**SUSQUEHANNA STEAM ELECTRIC STATION  
RESPONSE TO NRC REQUEST FOR ADDITIONAL  
INFORMATION (RAI) RELATIVE TO SUSQUEHANNA  
STEAM ELECTRIC STATION, UNITS 1 AND 2  
REVISED RESPONSE TO GENERIC LETTER 94-02:  
LONG-TERM STABILITY SOLUTION  
(TAC NOS. MC 1659 AND MC 1660)  
PLA-5771**

**Response to NRC Request for Additional  
Information Relative to the Revised Response to  
Generic Letter 94-02:**

**SUSQUEHANNA STEAM ELECTRIC STATION  
RESPONSE TO REQUEST FOR ADDITIONAL  
INFORMATION FROM NRC ON PROPOSED  
RELIEF REQUEST NOS. 3RR-01, 3RR-02, AND 3RR-04  
TO THE THIRD 10-YEAR INSERVICE INSPECTION  
PROGRAM FOR SUSQUEHANNA SES UNITS 1 AND 2  
PLA-5767**

**Response to NRC Request for Additional  
Information Relating to Relief Request 3RR-01**

**FIGURE 3RR-02.1, Rev. 1**

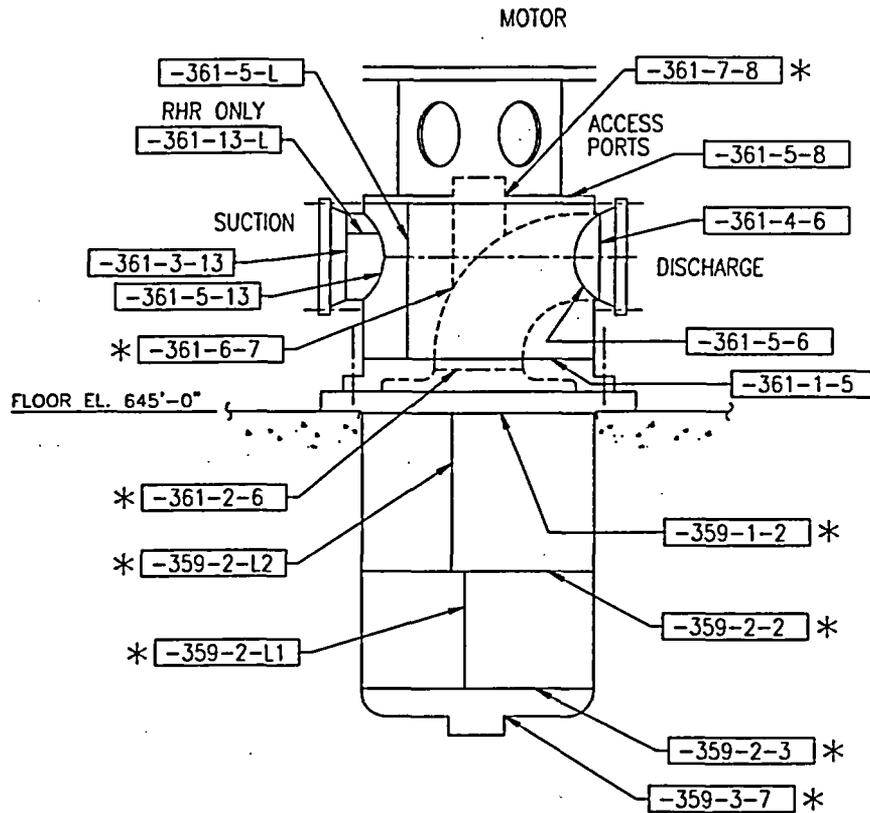
Please provide information regarding previous pump weld inspections including scope of inspections and results.

NOTE: A typographical error was discovered on Figure 3RR-02.1 for the CS Pump number. This error has been corrected in Revision 1 of the subject relief request (see Attachment B to Enclosure 2). Also, it should be noted that the weld nomenclature is slightly different between the pumps, but the number and location of the welds is consistent.
